**Date of Meeting:** June 4, 2015

**TOWN OF LEESBURG  
PLANNING COMMISSION PUBLIC HEARING**

**Subject:** TLZM-2013-0001, Crescent Parke

*Figure 2, Concept Plan*

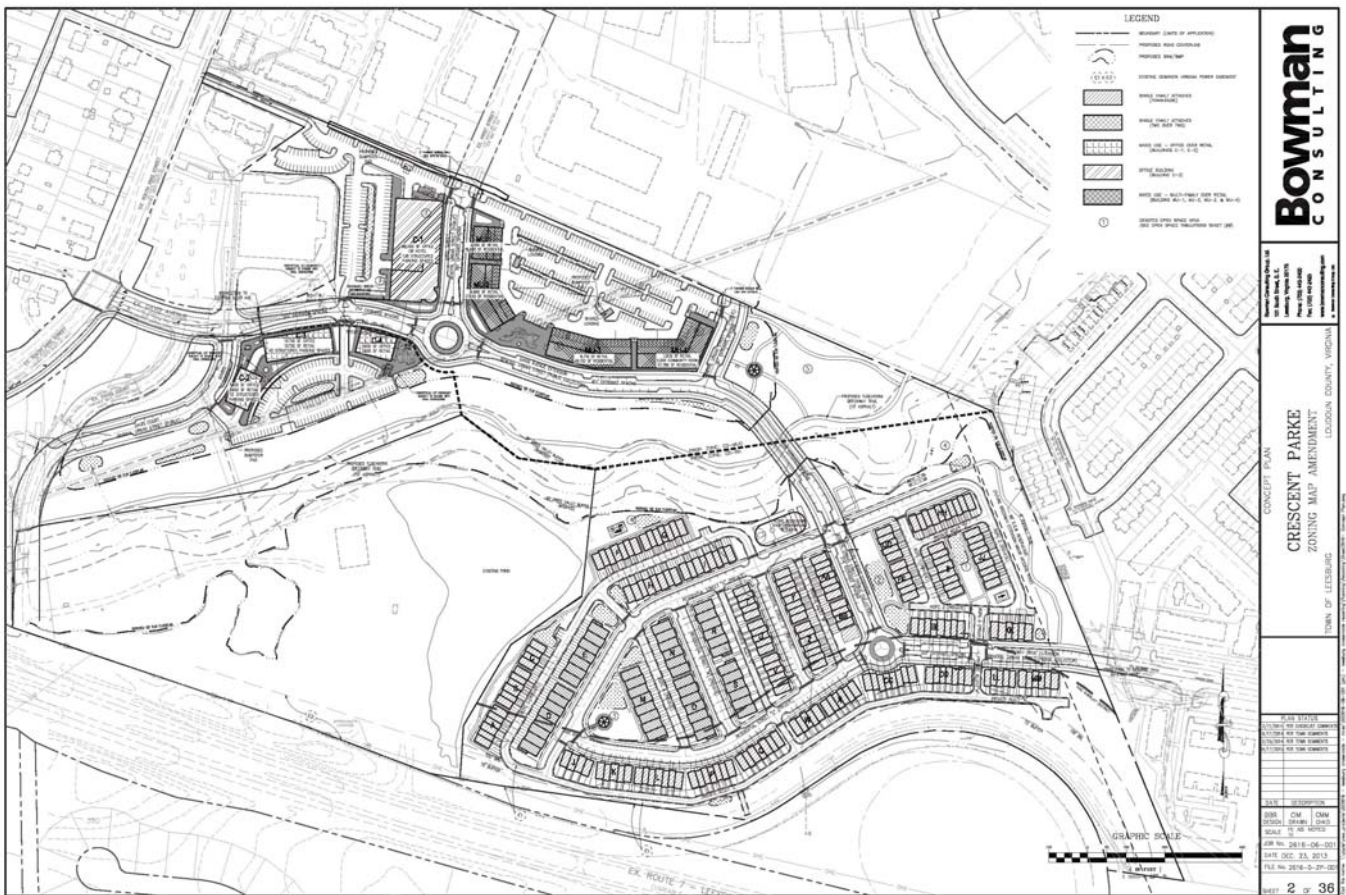
The land bay south of the Tuscarora Creek is proposed as CD-RH. Contrary to the Crescent District Master Plan and the intent of the current zoning district this land

bay is essentially a suburban neighborhood composed of 207 townhouses and 96 stacked townhouses or 2-over-2s.

*Figure 6, Fourth Submission*

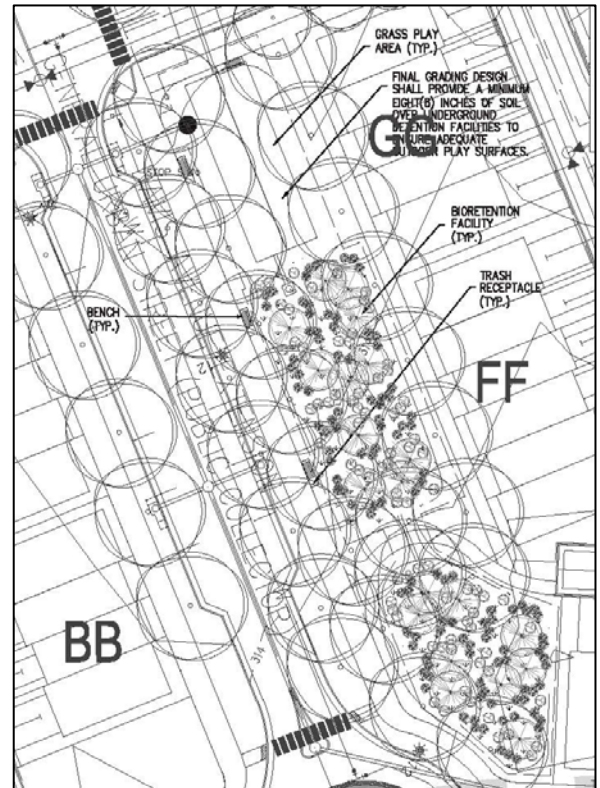
Staff notes the changes made with this revised submission continue to erode active recreation areas. To cite an example, the mews or pocket parks located in close proximity to residential units have been diminished with the expansion of biorentention facilities. See figures 5 and 6.
